# UNITED STATES PATENT AND TRADEMARK OFFICE

10/565,982

Melchor Daumal Castellon

<b>Office Action Summary</b>	<b>Application No.</b> 10/565,982	<b>Applicant(s)</b> DAUMAL CASTELLON, MELCHOR	
	<b>Examiner</b> Thomas Diaz	<b>Art Unit</b> 4171

6. Applicant discloses an intermediate shaft for a steering assembly as seen below.

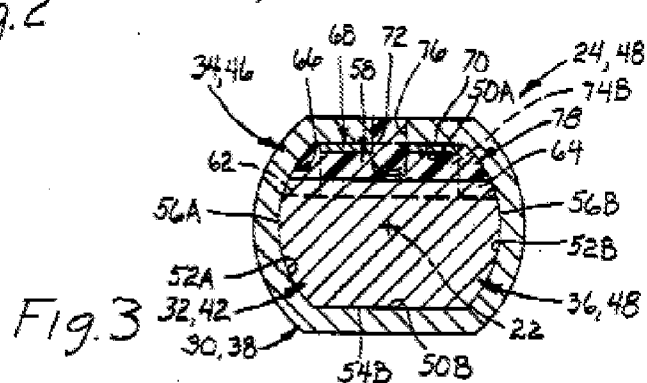
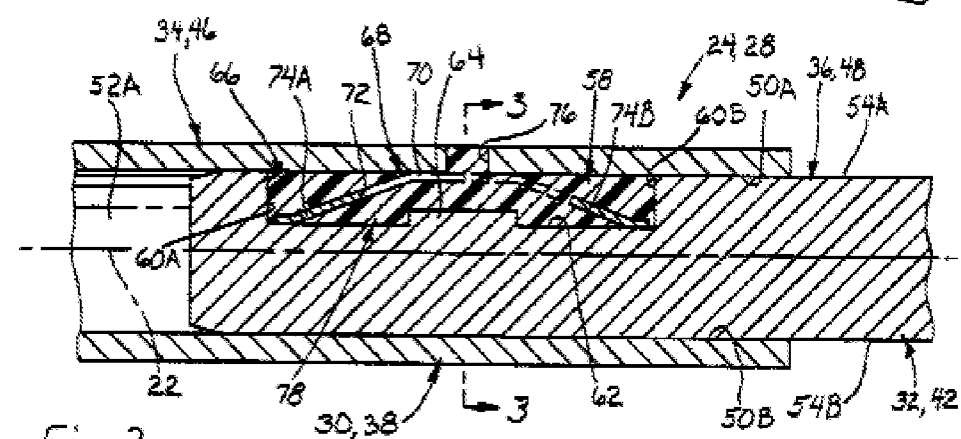
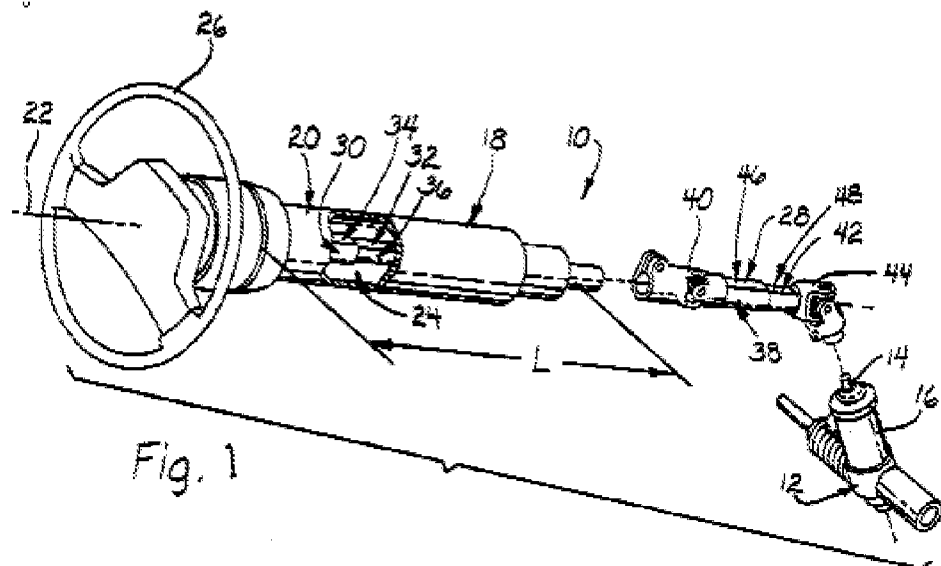
1. The drawings are objected to as failing to comply with 37 CFR 1.84(p)(4) because reference character “10” has been used to designate both a universal joint and a fastening cage recess. Corrected drawing sheets in compliance with 37 CFR 1.121(d) are required in reply to the Office action to avoid abandonment of the application. Any amended replacement drawing sheet should include all of the figures appearing on the immediate prior version of the sheet, even if only one figure is being amended. Each drawing sheet submitted after the filing date of an application must be labeled in the top margin as either “Replacement Sheet” or “New Sheet” pursuant to 37 CFR 1.121(d). If the changes are not accepted by the examiner, the applicant will be notified and informed of any required corrective action in the next Office action. The objection to the drawings will not be held in abeyance.

2. In addition to Replacement Sheets containing the corrected drawing figure(s), applicant is required to submit a marked-up copy of each Replacement Sheet including annotations indicating the changes made to the previous version. The marked-up copy must be clearly labeled as “Annotated Sheets” and must be presented in the amendment or remarks section that explains the change(s) to the drawings. See 37 CFR 1.121(d)(1). Failure to timely submit the proposed drawing and marked-up copy will result in the abandonment of the application.

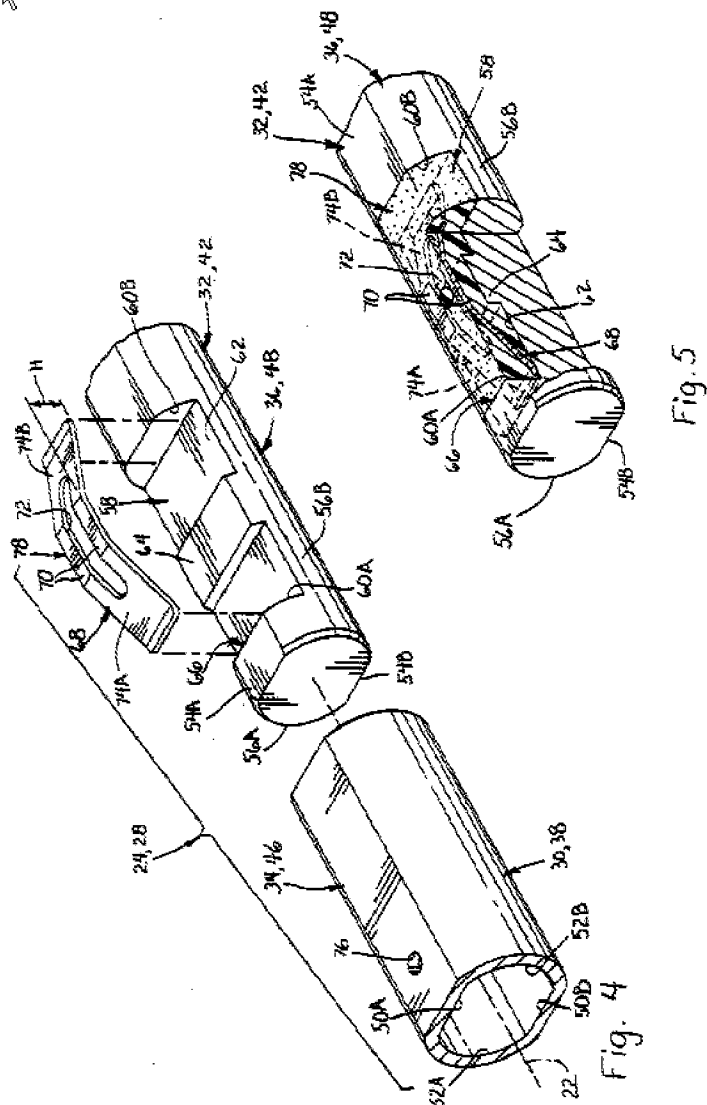
Dykema et al. disclose a similar apparatus seen below.

Dykema et al. teach a low sliding load intermediate shaft (col.1 line 66 to col. 2 line 7) in a motor vehicle steering column (col.1, lines 54-56). Dykema et al. discloses that the sliding members in the intermediate shaft have a minimized resistance to telescopic movement due to the low coefficient of friction in the interconnect between them. Dykema et al. further teaches a first member (fig. 2, **46**) corresponding to applicant's female member and a second member (fig. 2, **48**) corresponding to the male member. A spring having an uneven contact surface (fig. 4, **68**) corresponding to applicant's metal strips is placed inside the recess (fig.2, **58**) wherein there is a fastening cage (fig. 2, **78**) clamped to the external surface of the male member as seen in figure 2.

Figure 1a- Legend of MPEP materials

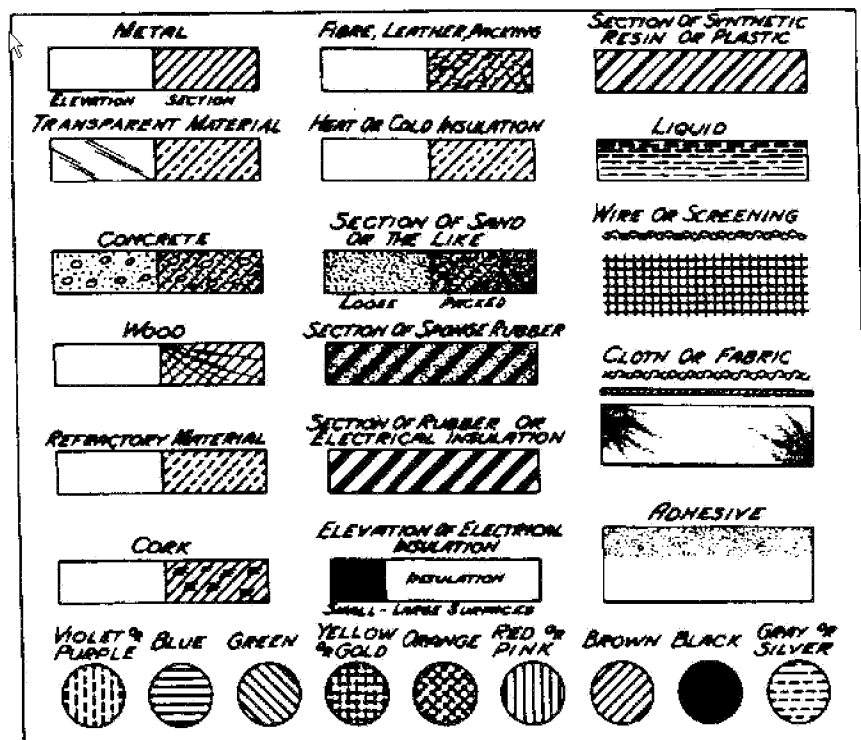
However, Section 608.2 of the MPEP depicts a legend for drawing symbols, seen below, such as the cross-hatching used in Dykema et al. in figure 5 (see below). Therefore, the examiner has reason to believe that the material taught by Dykema et al. for the spring would inherently be metal.
